CHATSWOOD TO SYDENHAM
**MARTIN PLACE STATION
MODIFICATION
SUBMISSIONS REPORT**

EXECUTIVE SUMMARY

Purpose of this report

Figure 4-1 Indicative station entry layout

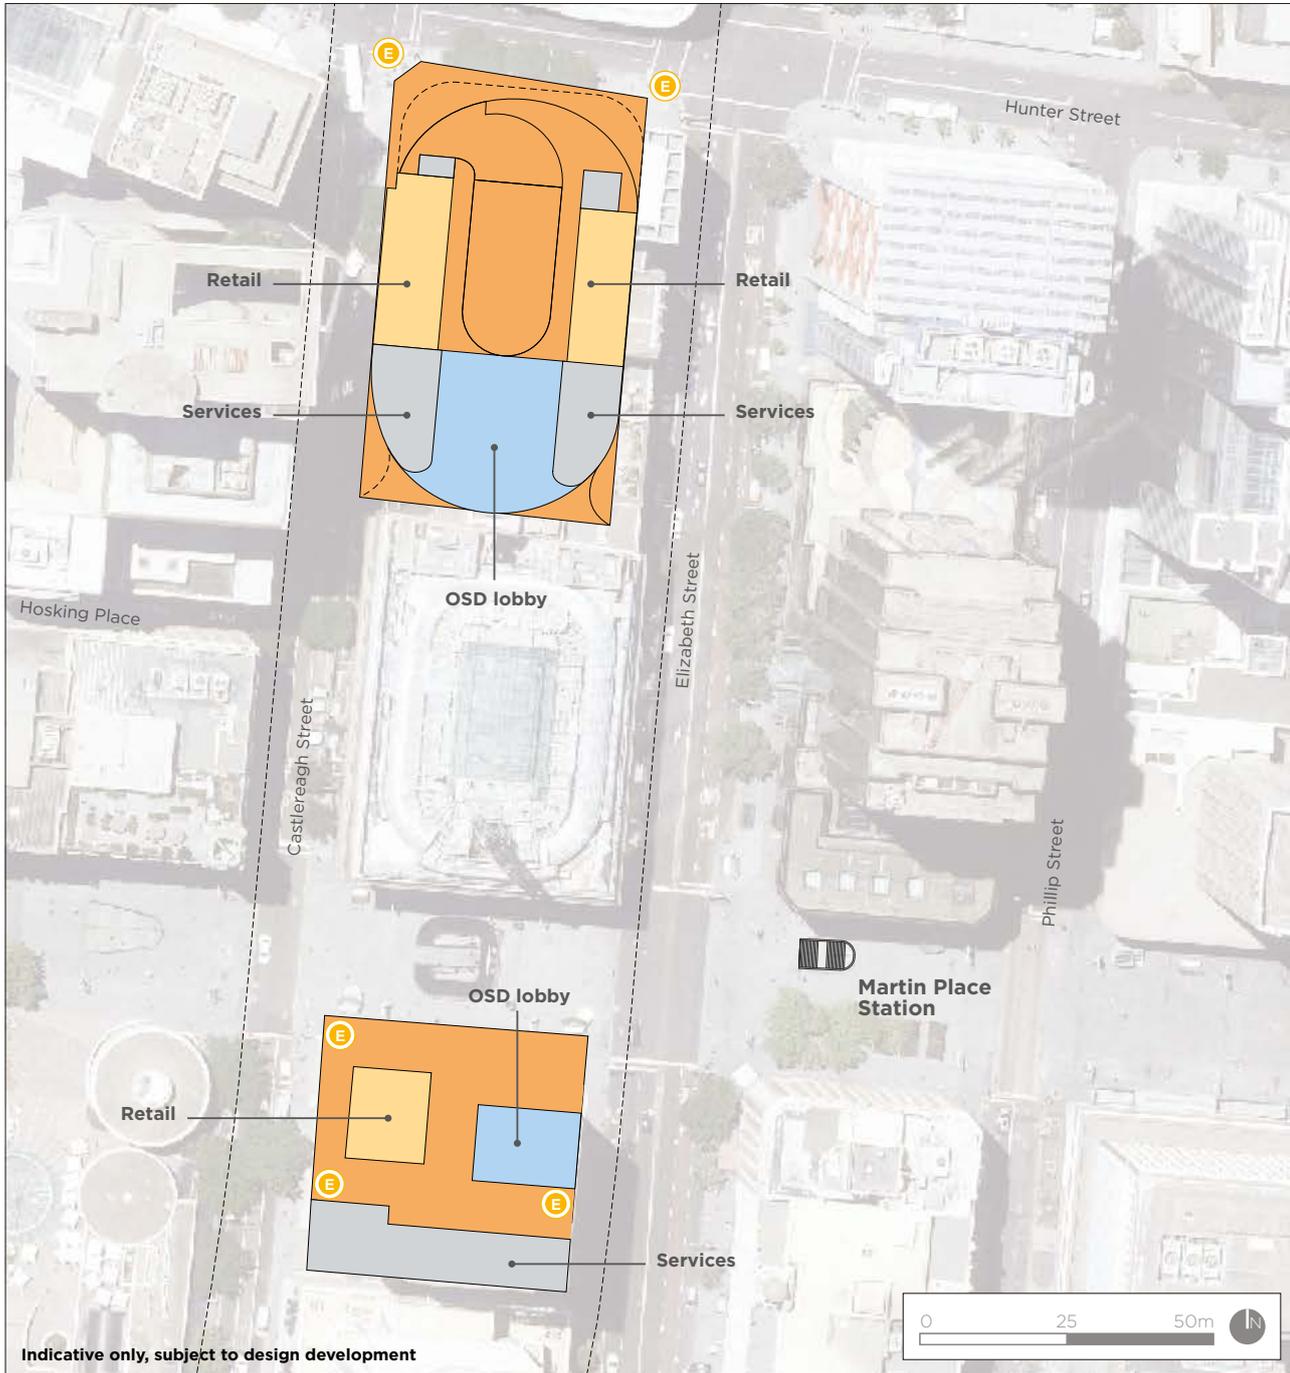
The plans for the proposed station entries are inconsistent with the cross-sections provided and are misleading. The plans show that the whole site area will be occupied by a pedestrian plaza / station lobby, with some service and operational area. This is not the case because, as shown by the cross-sections, it is clearly intended that some of this space will be occupied by over station development entries and retail, particularly in the northern station. Due to the inaccuracy of the plans, it is not possible to determine if the station area is larger than the approved works, but it appears that it is not.

The plan view of the station entries provided in the modification report shows a general station plaza / station lobby area as part of the conceptual station design. The submission from City of Sydney correctly identifies that some of this space would be used for retail purposes and entries to the over station development. This is due to the proposed modification representing a more integrated solution than the approved project.

Figure 4-1 shows an indicative plan of the station entries and the proposed retail and over station development lobby space. This layout is subject to change during development of the design. The ongoing design of the layout of the integrated station and allocation of retail spaces would be developed as part of the Station Design and Precinct Plans (required by Condition E101). Council would be involved in the preparation of this plan for Martin Place Station through consultation and collaboration.
